## Verification of Balance of System for Solar Photovoltaic Power Plant

*This paper presents results of the initial field inspection report of 10kWp Grid Connected Power Plant using Multi-crystalline PV Modules at IIT Gandhinagar-Ahmedabad. The inspection was carried out according to standard IEC 62446, Grid Connected Photovoltaic Systems - Minimum requirements for system documentation, commissioning tests and inspection, Edition 1, May 2009. Qualitative studies are made on physically visible defects such as gridline fading, corrosion of module frame, absence of grounding, hanging of wire cords, terminal box labeling etc. Initial verification takes place upon completion of a new installation or completion of additions/ alterations to existing installations. Periodic verification is to determine whether the installation and all its constituent equipment remain in a satisfactory condition for use. Here, the initial inspection is carried out and the effect of initial field exposure on the modules indicates that the qualification standard (s) needs to be reviewed and revised if the modules are to perform for long term under operating conditions.*

**Figure 1: Bolt position at the frame**

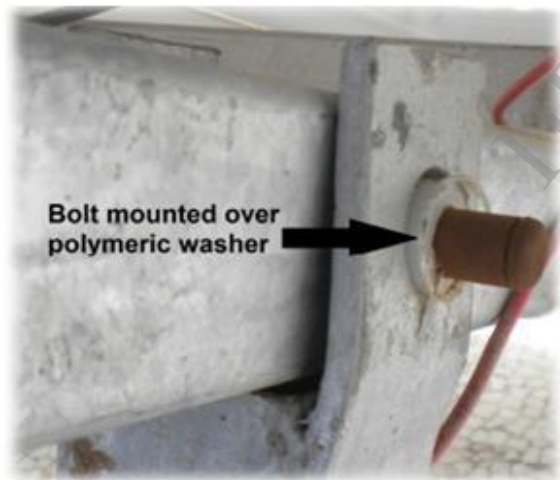
Between the AC and DC sides and that earth connections have been constructed so as to avoid corrosion (IEC 60364-7-712.312.2:2002). However, it was found that the mounting structure provided was considered as the means of grounding. The connection bolts of the structures were found to be corroded. Moreover the bolt was mounted over polymeric washer (Refer Figure 1) which rules out the continuity of grounding means.

**Figure 4 Length of lightning arrester falling**

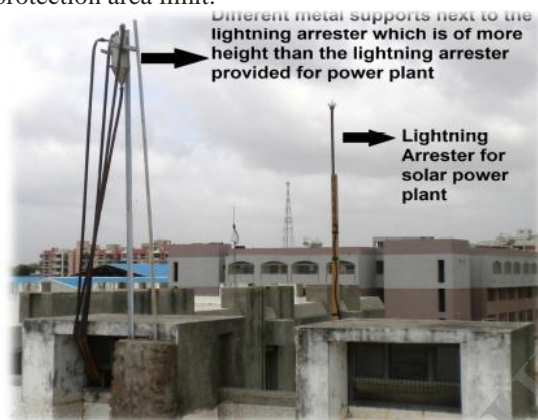
One more metal structure was present next to the existing lightning arrester (Refer figure 4). Also the lightning arrester fixed is slightly away from the PV Array installation (4 to 5m form the PV Array) which will not cover the entire PV Array within its protection area limit.
